TURKEY POINT PLANT UNIT NO. 4

AMENDMENT TO FACILITY OPERATING LICENSE

Amendment No. 79  
License No. DPR-41

SAFETY EVALUATION BY THE OFFICE OF NUCLEAR REACTOR REGULATION  
RELATED TO AMENDMENT NO. 86 TO FACILITY OPERATING LICENSE NO. DPR-31  
AND AMENDMENT NO. 79 TO FACILITY OPERATING LICENSE NO. DPR-41  
FLORIDA POWER AND LIGHT COMPANY  
TURKEY POINT PLANT UNIT NOS. 3 AND 4  
DOCKET NOS. 50-250 AND 50-251

FIG. 3.2-3

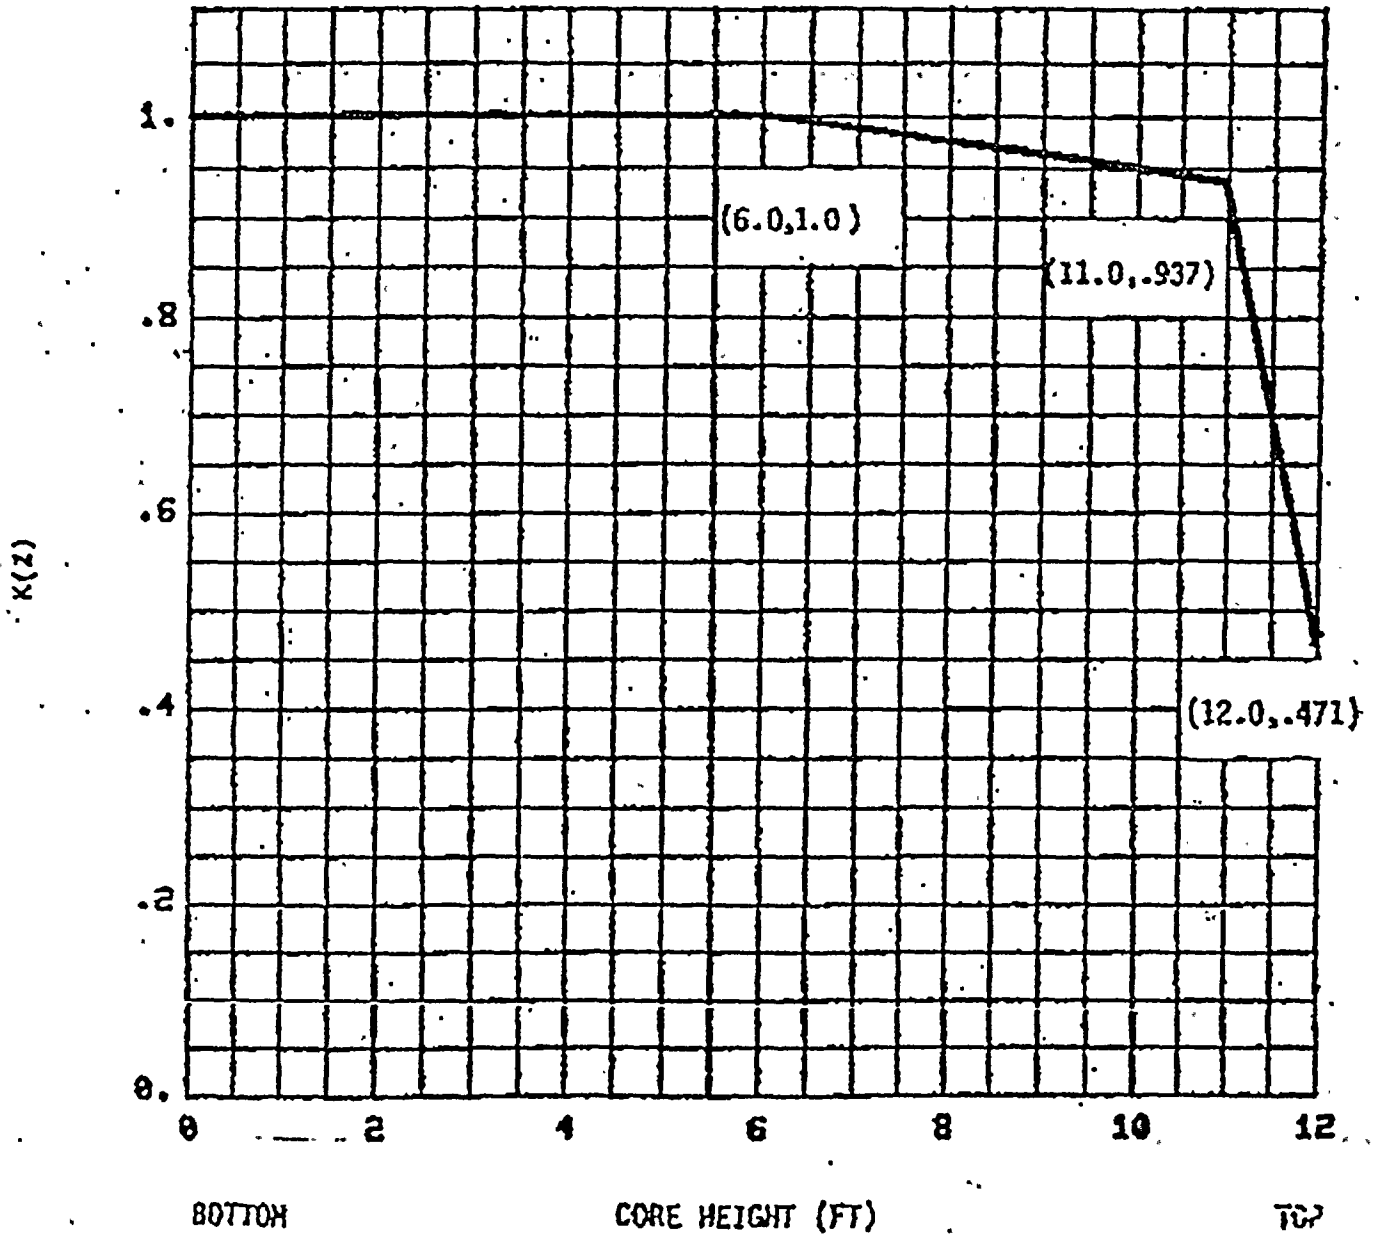
By phone call dated April 21, 1982, confirmed by a letter of the same date, as supplemented April 22, 1982, Florida Power and Light Company (the licensee) requested expedited action to amend the Technical Specifications for the Turkey Point Plant Unit Nos. 3 and 4. The amendments would replace an erroneous Hot Channel Factor Curve.

After Unit 3 began operation with the new steam generators it operated under the current  $K(z)$  curve (i.e. for 28% steam generator tubes plugged) since the ECCS evaluation for the new steam generators had not been submitted to the NRC for review and approval. Upon completing the necessary surveillance measures it was determined that the  $K(z)$  curve was in error.

Based on investigation by Westinghouse and the licensee of Figure 3.2-3 of the Turkey Point 3 and 4 Technical Specifications, it has been determined that the currently docketed figure is incorrect. Based on Westinghouse investigations it appears that the intercept of the second and third line segments in the region of 11 feet in core height has been incorrectly calculated for an FQ(Z) of 2.125. The current intercept coordinates of 11.2 feet, 0.849 reflect an incorrect calculation based on the use of FQ value of 2.125. Westinghouse has determined that the correct coordinates for the intercept should be 11.0 feet, 0.937. The licensee proposes that Figure 3.2-3 be modified to reflect the following break points:

0 feet	1.0
6.0 feet	1.0
11.0 feet	0.937
12.0 feet	0.471

Based on the conference call and the supplemental application the staff finds that error was properly corrected and the new K(z) curve is acceptable. Previous operations under the old K(z) curve which was in error did not violate any Technical Specifications because the incorrect K(z) curve was conservative relative to the corrected curve.
